REQUEST FOR COUNCIL ACTION

AGENDA SECTION: PUBLIC HEARING	ORIGINATING DEPT: PLANNING	ITEM NO. E-4
ITEM DESCRIPTION: Final Plat #03-04 to be known as Manor Woods West Fourteenth. The property is located south of 5 th Street NW, north of Manor Brook Drive NW, west of Manor Park Drive NW and allows of the continuation of Manor Ridge Drive NW.		PREPARED BY: Mitzi A. Baker, Senior Planner

RE: Final Plat #03-04 to be known as Manor Woods West Fourteenth. The property is located south of 5th Street NW, north of Manor Brook Drive NW, west of Manor Park Drive NW and allows of the continuation of Manor Ridge Drive NW.

MANOR WOODS WEST FOURTEENTH SUBDIVISION

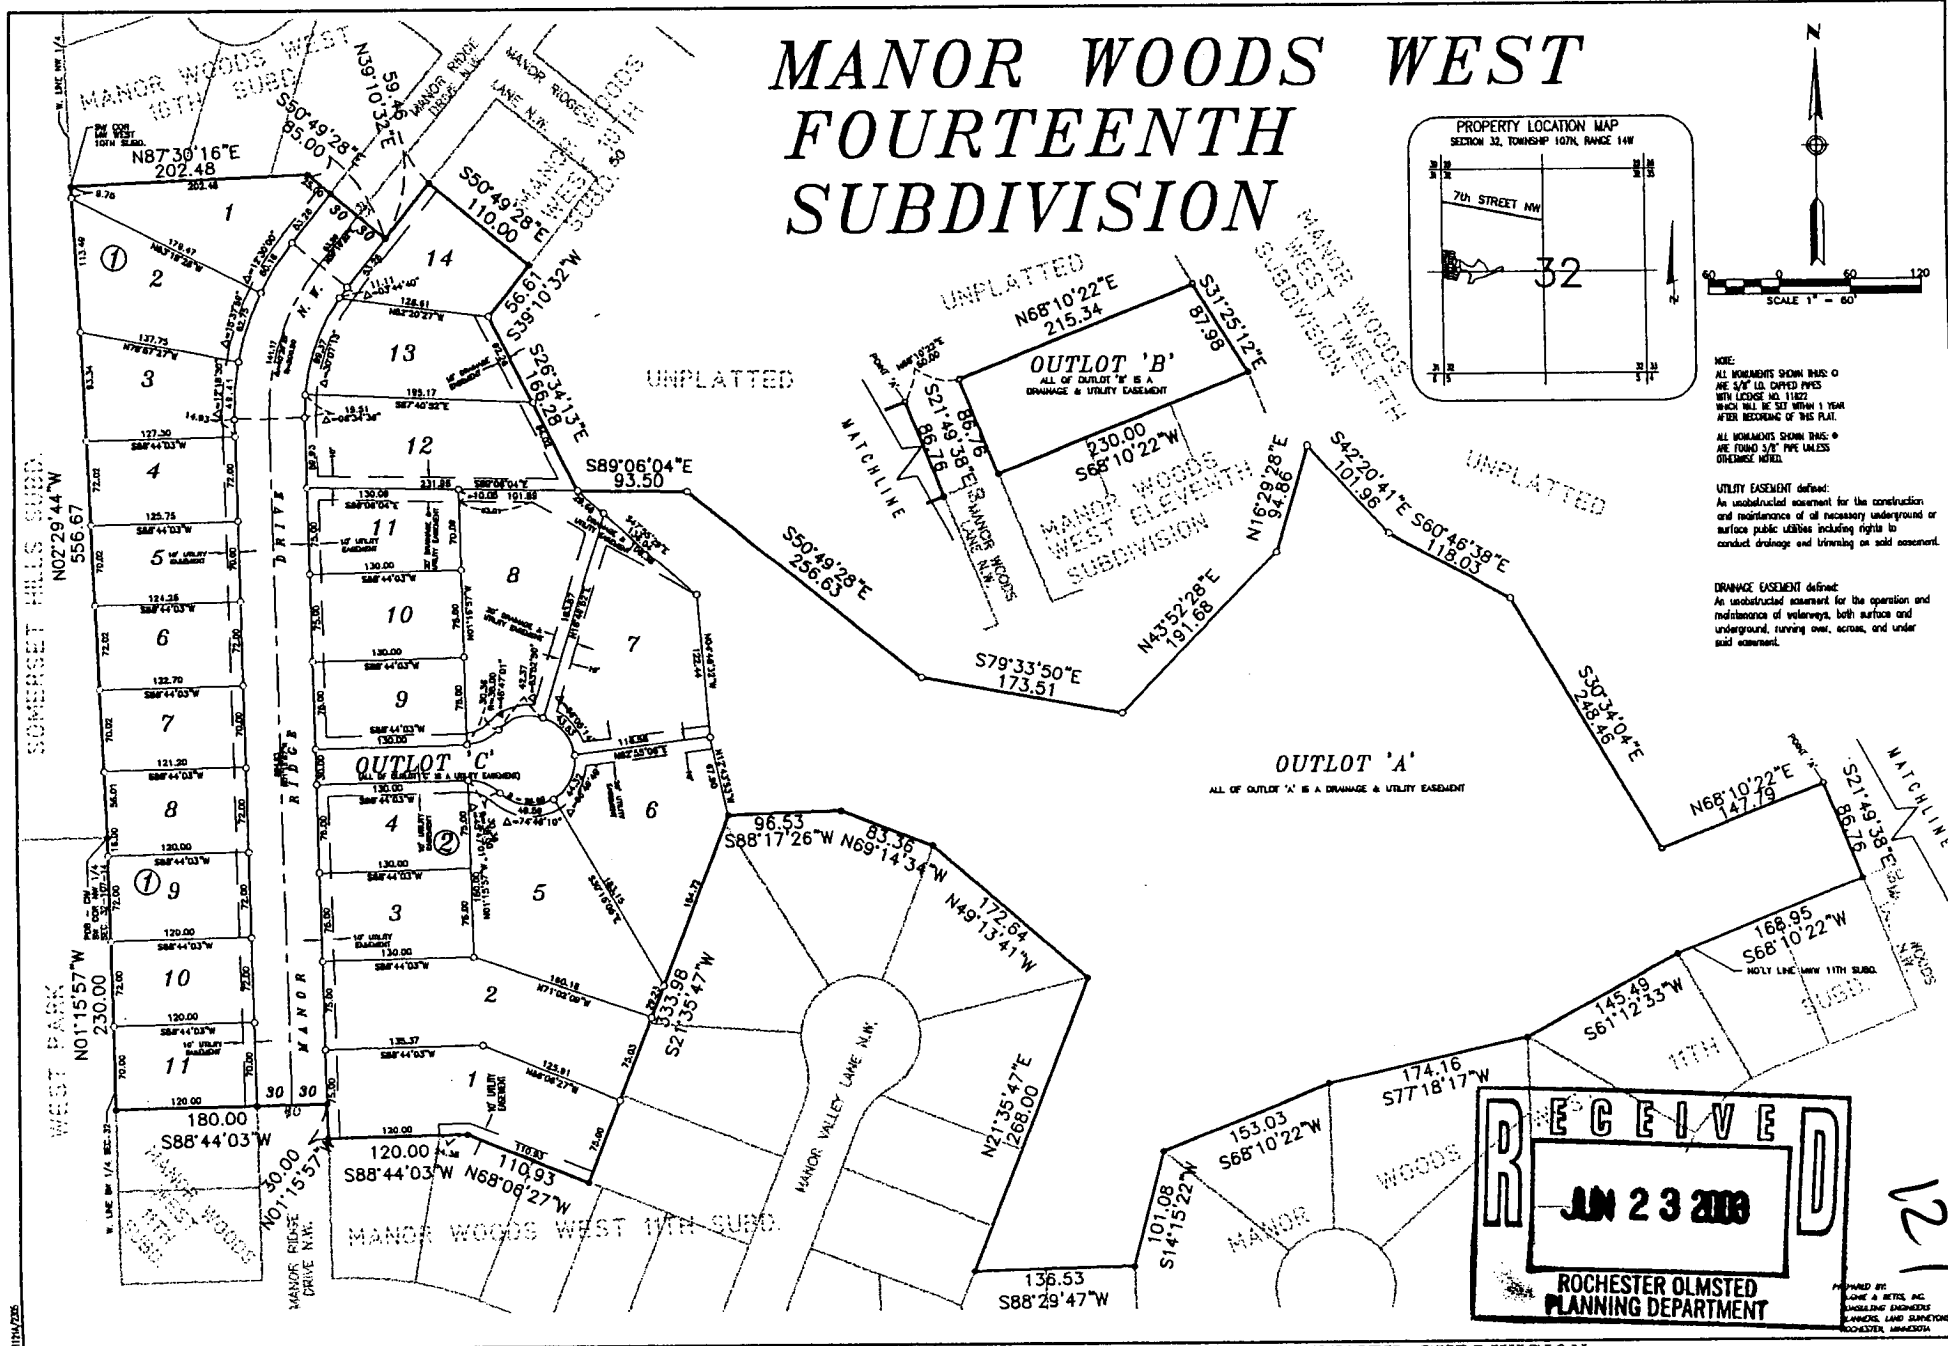
This Plat should not be approved in its present form. Right-of-way for Manor Woods Lane, located between Outlot A and Outlot B should be included in the Plat. The Plat should be revised to include dedication of this right-of-way prior to Council action on the Plat. If a REVISED Plat is submitted, including the additional right-of-way, staff would recommend approval subject to the following conditions/modifications:

- 1. The 86' access to Outlot A does not provide adequate access for maintenance of Outlot A. Dedication of access easement(s) to Outlots A and B shall be provided to the City prior to or concurrent with final plat documents, in a form and location acceptable to Rochester Park and Recreation and Rochester Public Works.***
- 2. Parkland dedication shall be in the form of cash in lieu of land in the amount of \$8,540 with payment due prior to recording the final plat documents.***
- 3. Per the referral comments from the Planning Department GIS/Addressing Staff, the following fees shall be paid prior to recording the final plat documents: E911 Addressing Fee \$500.00, GIS Impact Fee \$340.00.***

The 86' access to Outlot A does not provide adequate access for maintenance of Outlot A.

1. A Development Agreement has been executed for this Property.
 2. Execution of a City / Owner Contract will be required prior to construction of public infrastructure.
 3. Dedication of an easement to the City is required for access to Outlots 'A' & 'B'.
- ❖ Development Charges are addressed in the executed Development Agreement.
